# Prospect Park West Bicycle Path and Traffic Calming Update

Community Board 6  
April 29, 2010

NYC Department of Transportation  
Office of Alternate Modes

## Full Bicycle Signal Controls

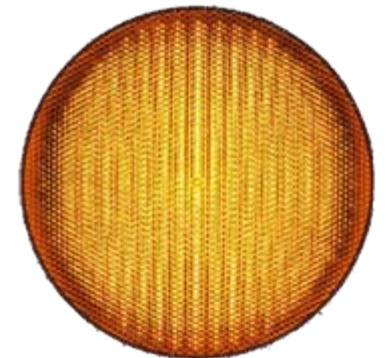
*Community requested bicycle signals @ all signalized intersections*

- Not warranted at low conflict crossings
- HRP uses bicycle signal controls only at vehicle crossings
- Many gaps in both bike and pedestrian traffic on PPW

**Prospect Park West Double Parking Frequency  
Saturday, May 9, 2009, 7AM - 7PM**

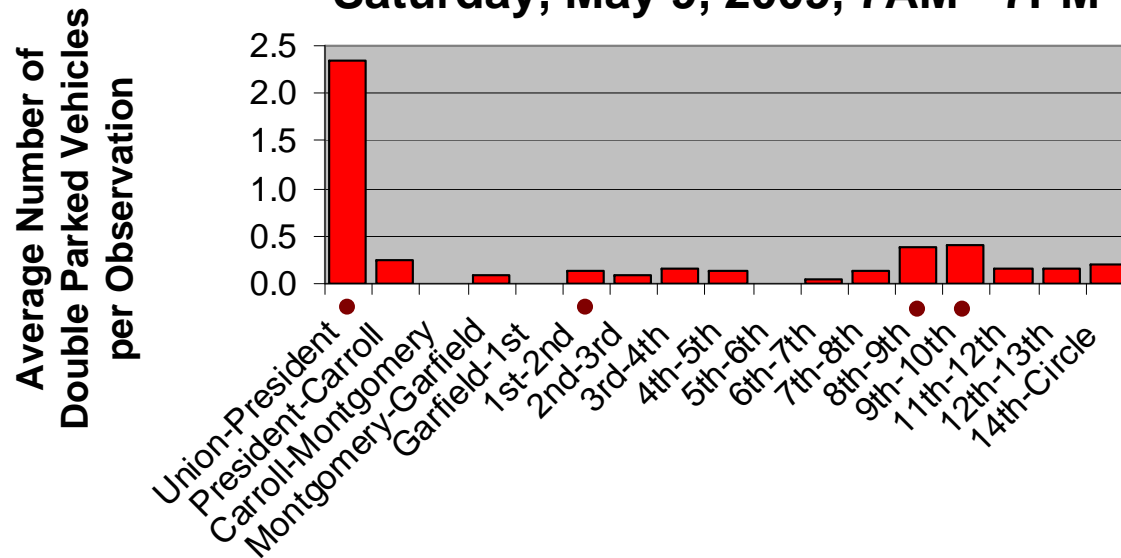
*Community expressed concern over risk of double parking*

**Daytime loading zones added at four locations**

9th Avenue Parking Protected Bike Path

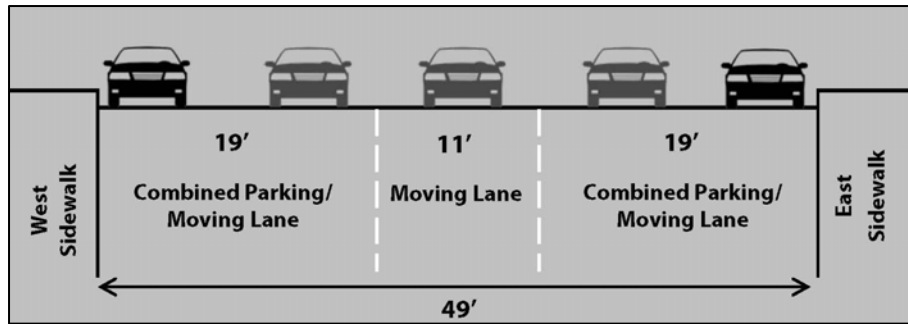
*Community requested concrete medians instead of striped buffers*

Striped buffers provide:

- Safe vehicle loading
- Unobstructed stormwater drainage
- Necessary width for street cleaning
- Rapid installation

**Example of proposed configuration:  
Kent Avenue, Brooklyn**

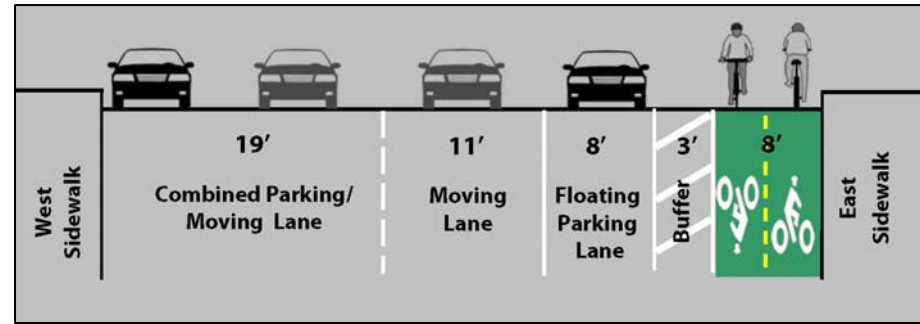
*Community requested wider parking lanes*

Revised design maintains existing markings and provides wider parking lanes than original DOT design
